Original Rib W1

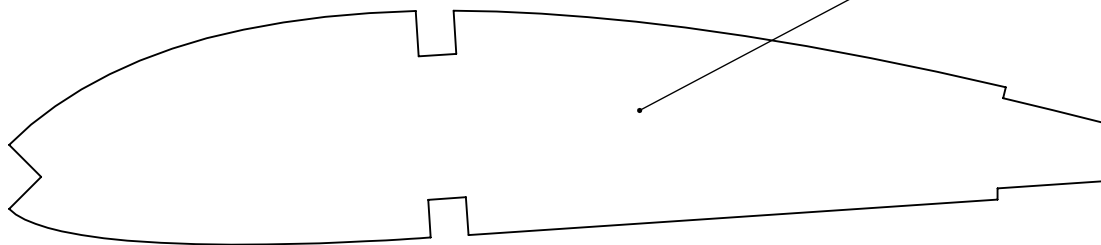
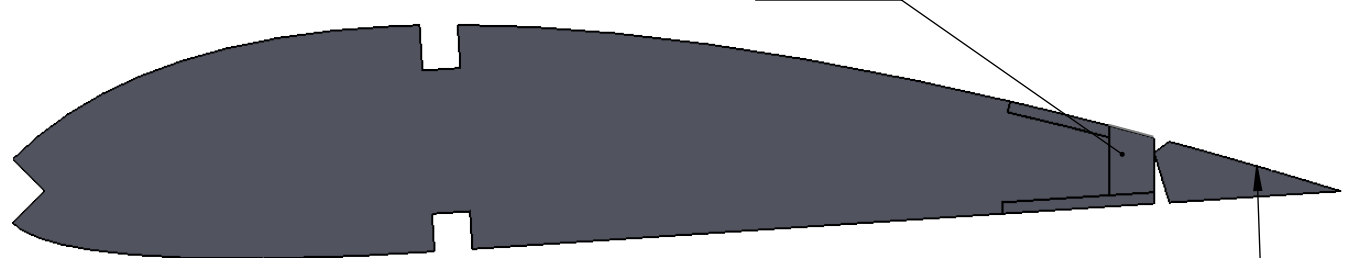
CG located at mid-spar plus/minus 3 mm
For GG choose forward position

Aileron modified Rib

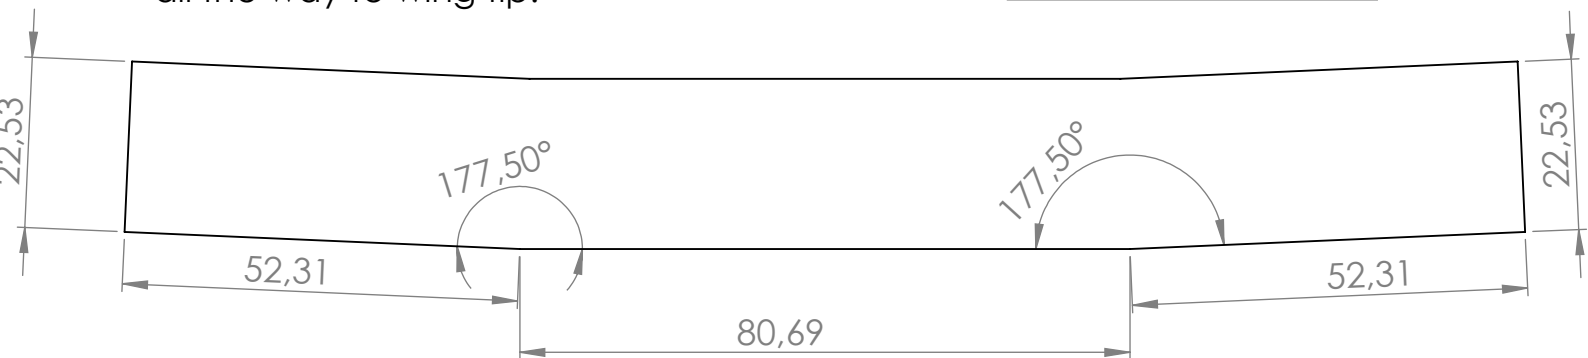
Rib modification to accept ailerons,
mods from first rib after central sheeting
all the way to wing tip.

Preshaped Triangular
Trailing edge $\frac{1}{3} \times 1"$
